AGENDA
DESIGN COMMISSION
Community Room, 3rd Floor
Arlington Heights Village Hall, 33 S. Arlington Heights Rd.
Arlington Heights, IL 60005
February 25, 2025
6:30 PM

MINUTES OF THE VILLAGE OF ARLINGTON HEIGHTS DESIGN COMMISSION

ARLINGTON HEIGHTS MUNICIPAL BUILDING
33 S. ARLINGTON HEIGHTS RD.
JANUARY 28, 2025

RENOVATION AND NEW POOL & BATHHOUSE
ARLINGTON HEIGHTS PARK DISTRICT
500 & 501 E. Miner Street, Arlington Heights, Illinois 60004

BASIS OF DESIGN: ENVISOR UNIT MOUNTED SCREENING SYSTEM, CITY SCAPES, INC.

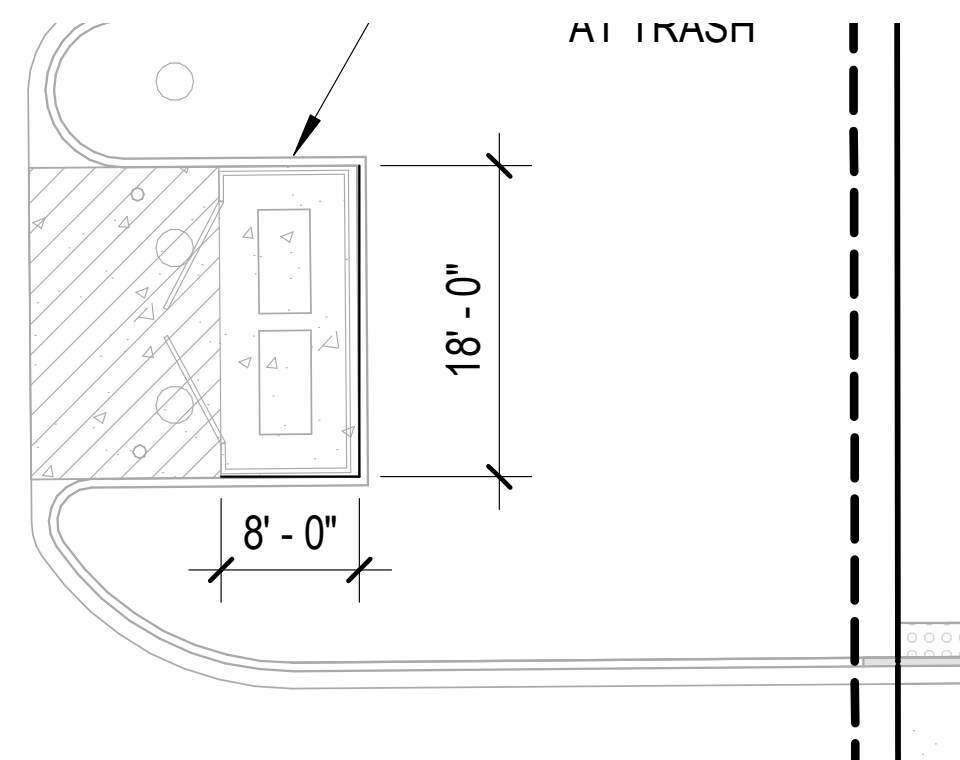
- d) **Rooftop Mechanical Screen.** The existing building has rooftop mechanical equipment located on a flat roof area on the south side of the building. The petitioner is proposing to add a brown color corrugated metal screen to conceal the equipment from view. Equipment screening is required, but Staff objects to the proposed screening design which does not fit with the character of the building. Staff recommends that other screening solutions be explored. This area of the building has a partial parapet wall with sections of open metal railings. The petitioner should explore the possibility of replacing the open railings with solid decorative panels to screen the equipment in a more architecturally compatible way.

- Vestibule and Elevator Addition. The profile of the roof eave was not changed, but a small jog was added where it meets the existing building wall.
- Raised Deck. No changes.
- Rooftop Mechanical Screen. The screening material has been changed from corrugated metal to smooth plastic panels.

NOTE: DUE TO THE ADDITIONAL STRUCTURAL SUPPORTS
REQUIRED TO REINFORCE ANY CONNECTIONS TO THE EXISTING
ROOF, UNIT MOUNTED SCREENS ARE THE FEASIBLE SOLUTION.

PROPOSED TRASH ENCLOSURE

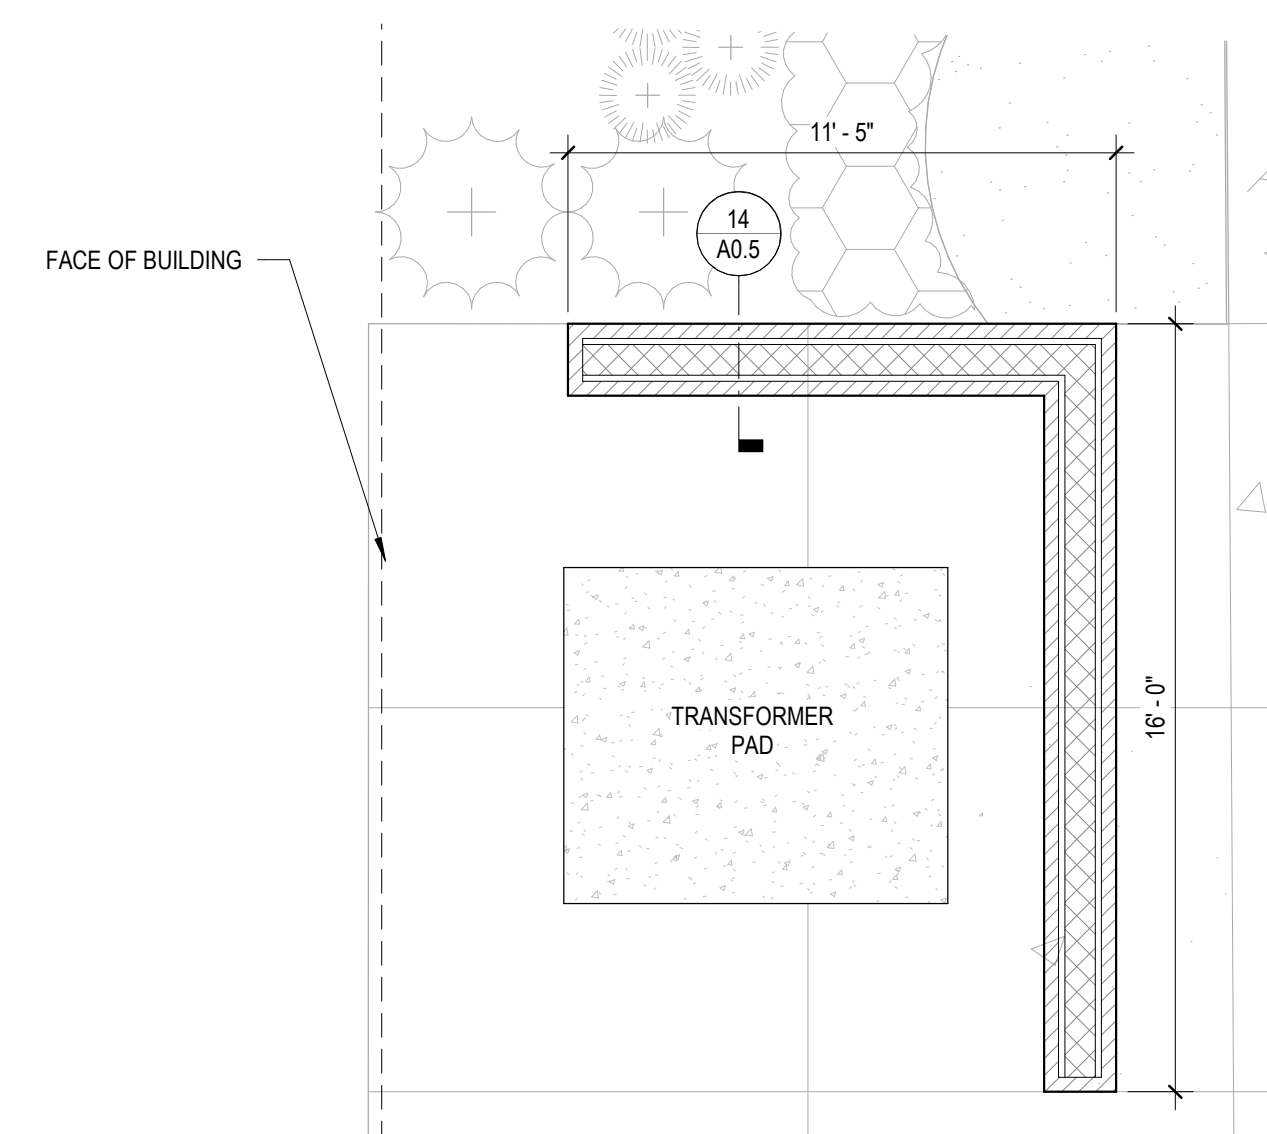
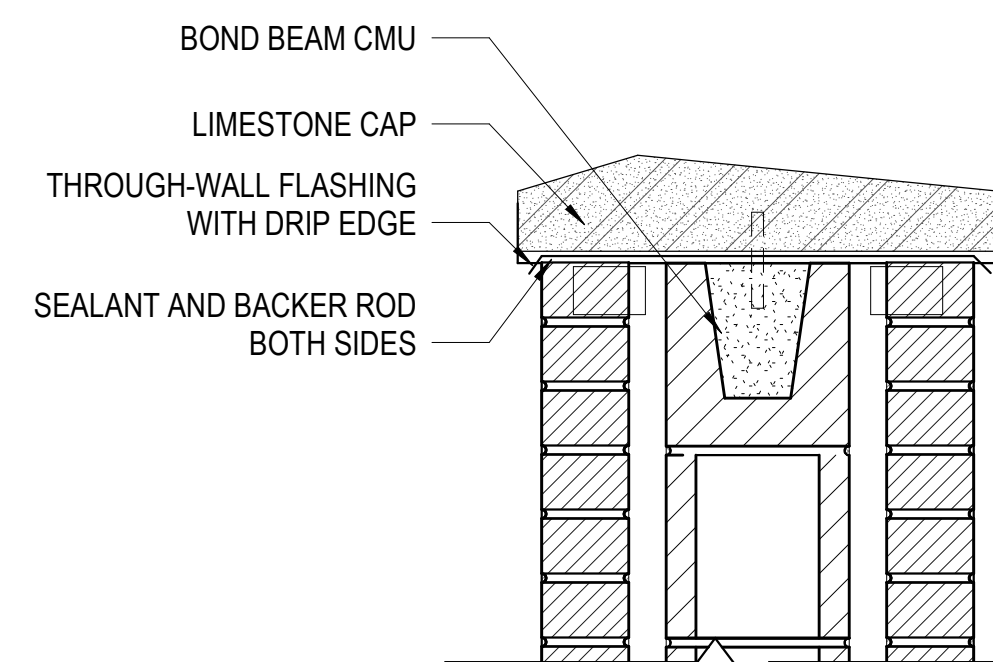
e) Trash and Transformer Enclosure. The plans include a trash enclosure and a transformer enclosure in front of the new bathhouse. The enclosures are proposed to be made of solid Trex composite fencing. The Design Commission should evaluate the appearance of these enclosures.

1 EXTERIOR ELEVATION - NORTH
1/8" = 1'-0"

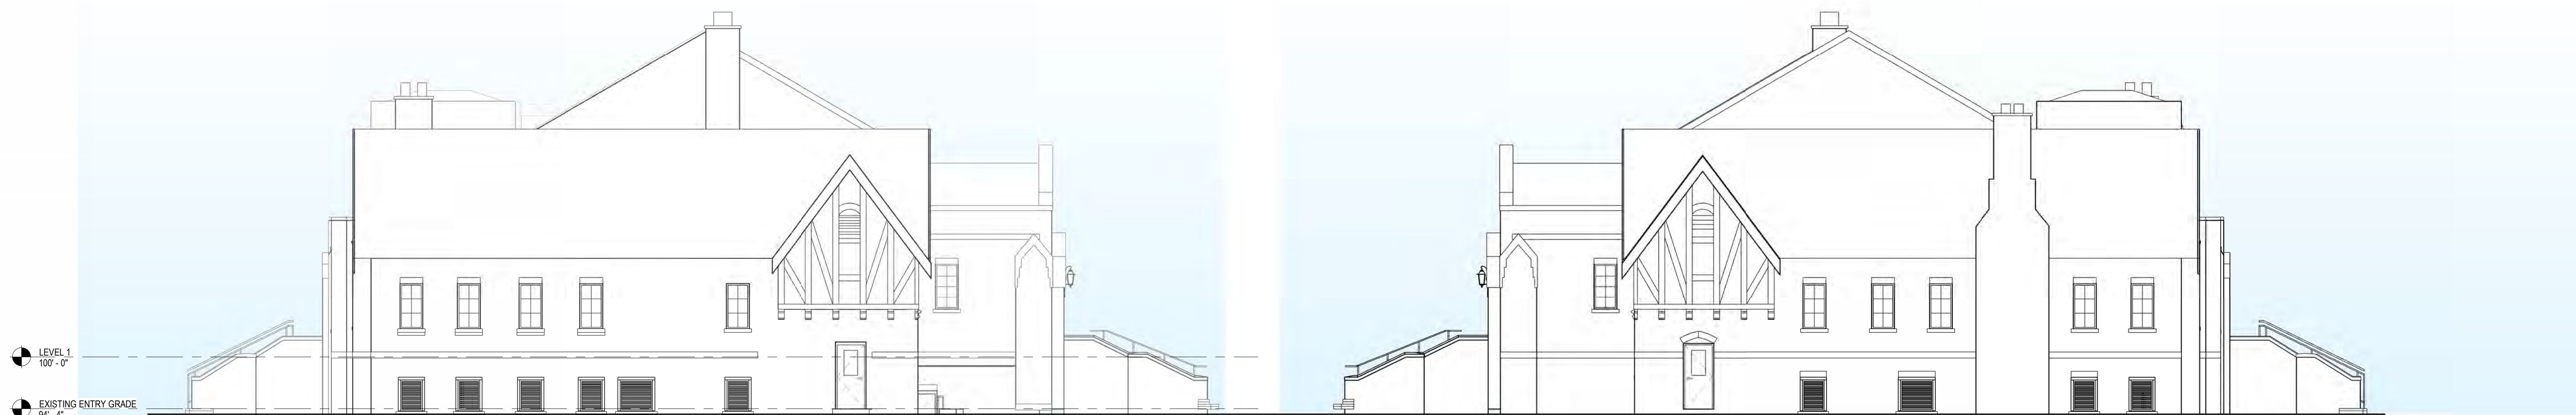
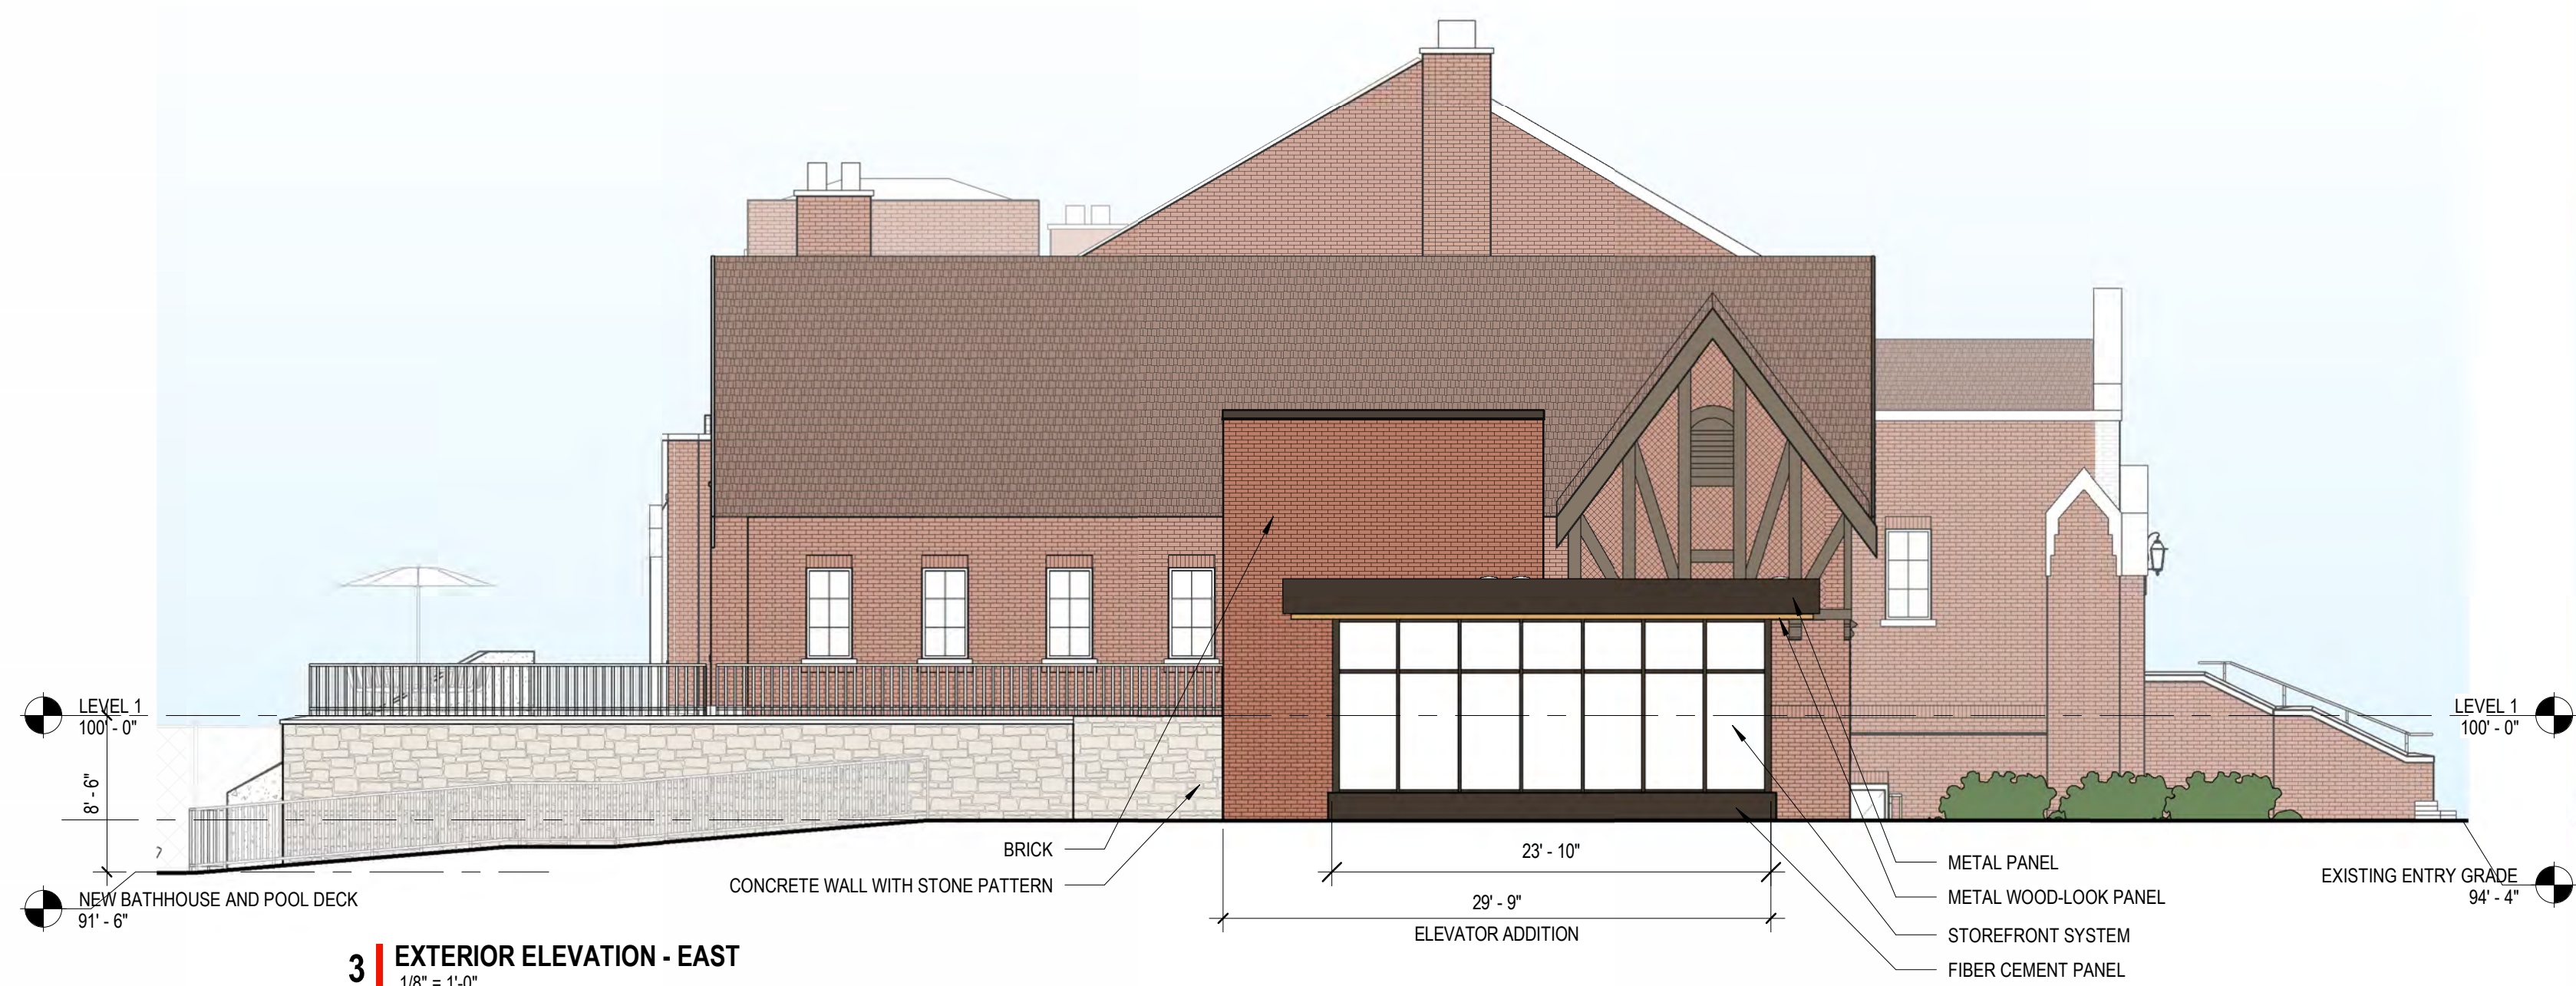
- c. Decorative Light Fixtures. The only light fixtures shown on the front elevation appear to be wall pack style fixtures at the service doors. It is recommended that all exterior light fixtures be a more decorative style to add design interest to the building. Additionally, it is recommended to add more decorative light fixtures on the front elevation to enhance the building appearance.

2. Back (West) Elevation. In contrast to the beautiful view of the existing Community Building from the pool area, the proposed bathhouse building lacks detail and interest.

- a. Windows and Doors. The large brick wall is mostly blank with minimal windows and doors. The overall composition lacks rhythm. Doors and windows are located on the façade based on the floor plan, and the random appearance does not complement the balanced appearance on the existing Community Building. False windows could be added to help balance the façade.
- b. Locker Room Entrance. The entrance to the Locker Rooms could be highlighted with a boxed bumpout including limestone trim and decorative light fixtures.
- c. Decorative Light Fixtures. As noted on the front elevation, the wall pack light fixtures should be replaced with decorative light fixtures.

DESIGN INTENT

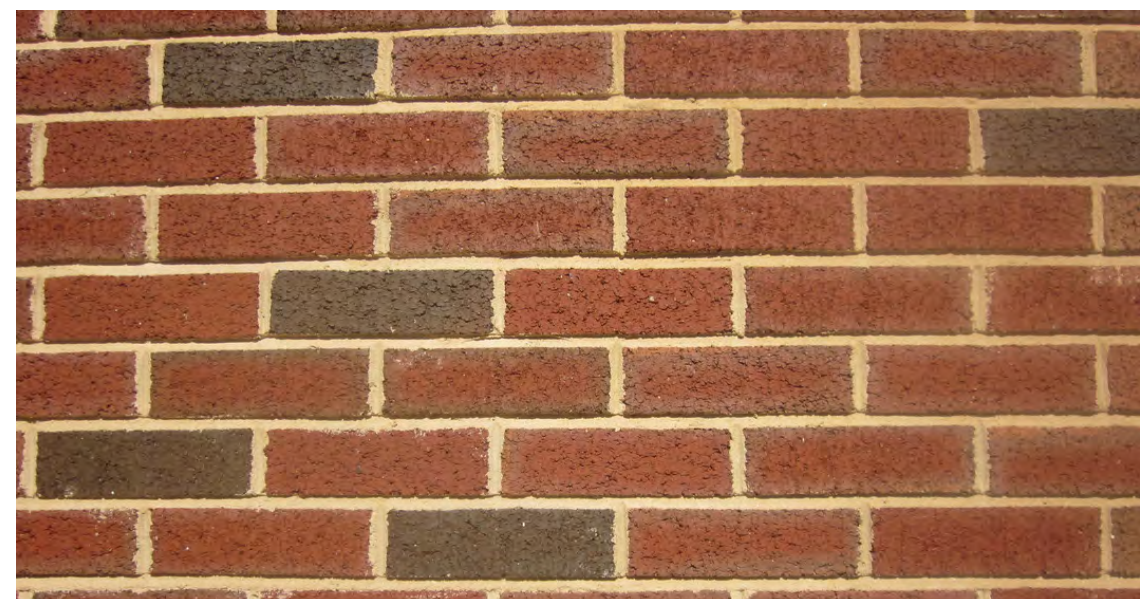
a. Vestibule and Elevator Addition. Evaluate the profile of the roof and the roof connection detail to the existing building.

- Window Replacement. The Design Commission had no objection to the proposed replacement windows.
- Vestibule and Elevator Addition. Overall, Staff and the Design Commission were in favor of the design of the addition. However, the Design Commission did question if the roof fascia could be thinner, as well as if it could connect to the existing building wall in a less abrupt way.
